Review of Monk Lakes Environmental Statement Groundwater Impact Assessment

Hydrogeological advice to MBC in relation to
planning application ref. 11/1948

July 2019

Maidstone Borough Council
Maidstone House
King Street
Maidstone
Kent ME15 6JQ

Figure 1: Typical sections of proposed surface water ditch and groundwater interceptor drain

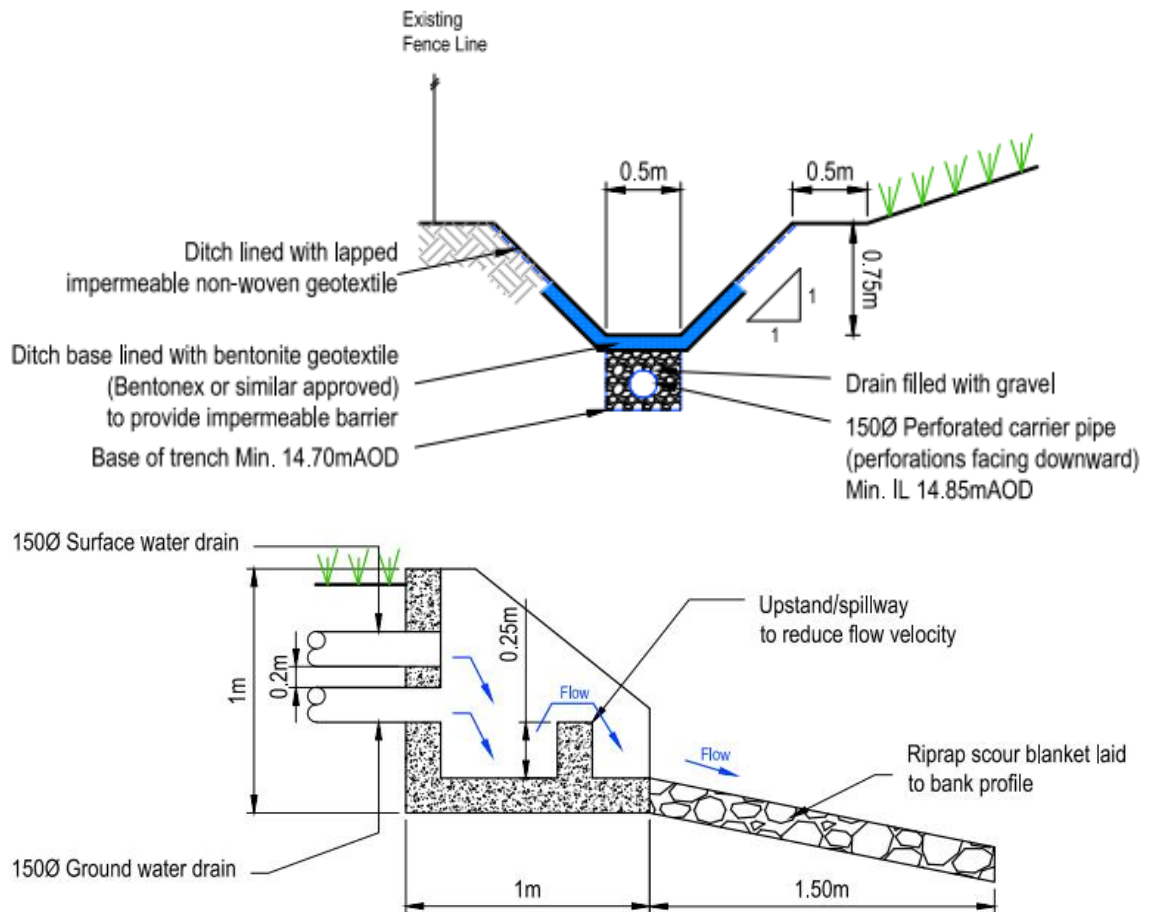
- 2.3.2 The base of the proposed trench (in which the perforated section of pipe would be set) slopes downward from 14.95 to 14.7mAOD, at which point solid pipe would be used to convey flow through the River Terrace deposits to the outfall (to avoid re-infiltration of the water).

- 2.3.3 The Applicant states (Hafren Water, 2019, pp. 11,38) that the ditch modifications would be undertaken exactly as specified in the drainage strategy report. However, in Section 4.1 (Hafren Water, 2019, pp. 30-31) it is stated that additional weirs and non-return valves would be installed to attenuate discharge flow and prevent inflow from the River Beult, when in flood.

- 2.3.10 Based on a ditch bed gradient of 1 in 455 (determined from the Interceptor Drain Long Section shown on drainage strategy drawing 29431/001/SK03), the carrying capacity of the proposed 150mm carrier pipe would be 8.2l/s. The proposed design therefore appears to have insufficient capacity to ensure its long-term effectiveness.

- 2.3.13 It is noted that the side slopes of the drainage ditch are relatively steep, which may result in some settlement that could (in addition to reducing its capacity to carry surface water) adversely impact on the integrity of the impermeable liner.

3.1.10 Our review of the design presented for the groundwater interceptor system indicates that the proposed 150mm carrier pipe may have insufficient capacity for the anticipated volume of groundwater inflow. Pipe capacity should be reviewed and revised by the Applicant during development of the detailed design.

Figure 2: Schematic showing effect of proposed mitigation on groundwater level

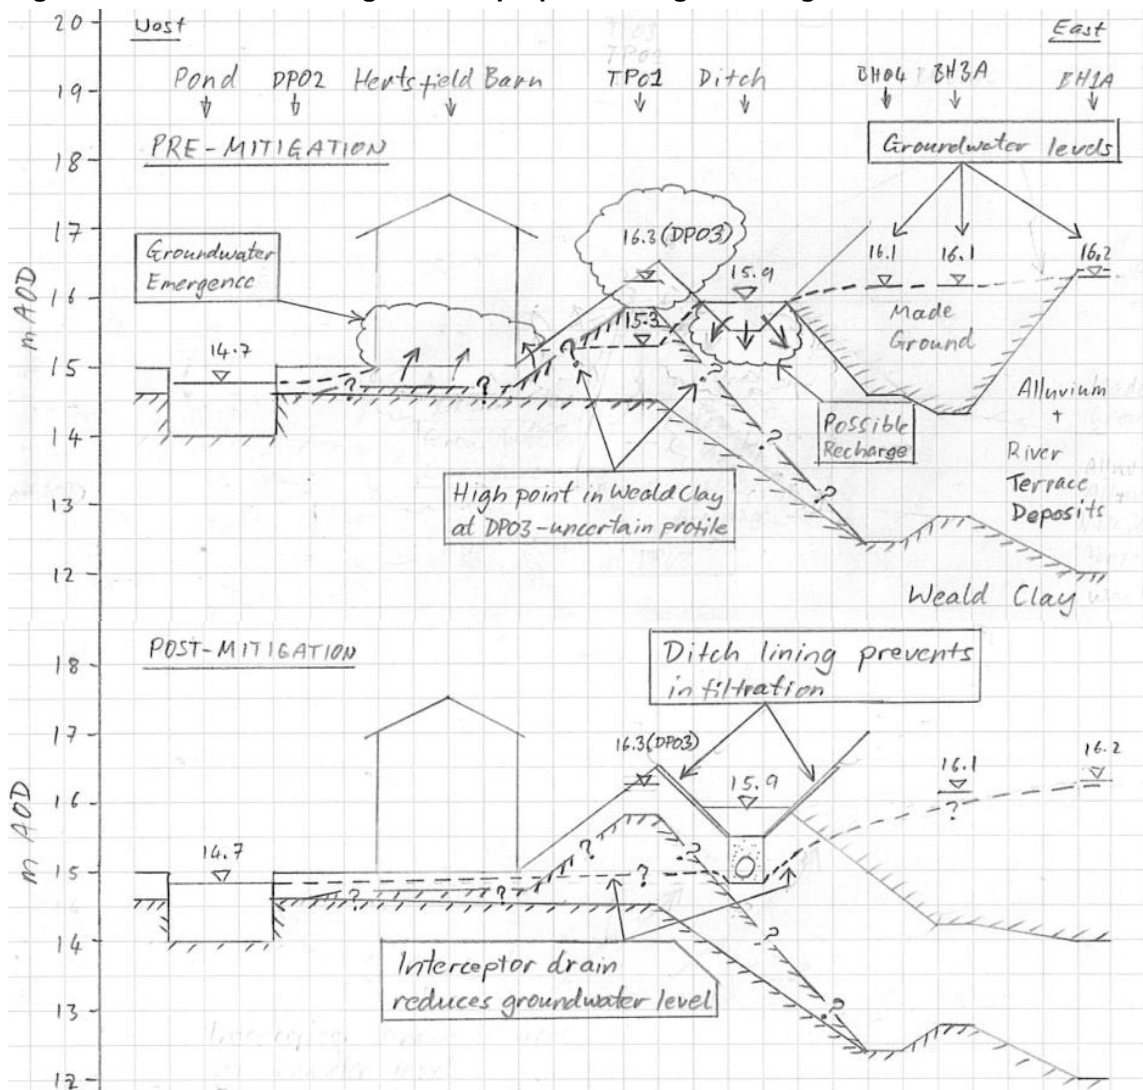
- 2.3.6 The mechanism by which the groundwater interceptor would prevent offsite waterlogging is shown in the schematic below, which this illustrates the key concepts described in Table 1. In our opinion the design is conceptually sound and should intercept groundwater before it emerges at the surface.

- 2.3.7 Its effectiveness would depend on a number of parameters that should be subjected to sensitivity testing during development of the detailed design. In particular, off-site groundwater levels appear to be naturally shallow. The outline design recognises the need to place the interceptor drain as low as possible in the ground, to maximise drawdown below the off-site receptors without impacting on the water level of Hertsfield Farm pond. Given this likely sensitivity in the design, it would be advisable to confirm the elevation of the pond water level.

- 2.3.8 Sensitivity (of the design) to aquifer permeability and thickness; and, the potential for future increases in groundwater level should also be considered.

- 2.3.12 The elevation of the interceptor drain relative to off-site receptors is critical to the effectiveness of the system and to prevent any adverse impact on the water level of Hertsfield Farm pond. The design is reliant on a single water level measurement taken by ESI in 2015. It is recommended that this water level measurement is confirmed as accurate and that any other relevant off-site receptor elevations are sought prior to detailed design.
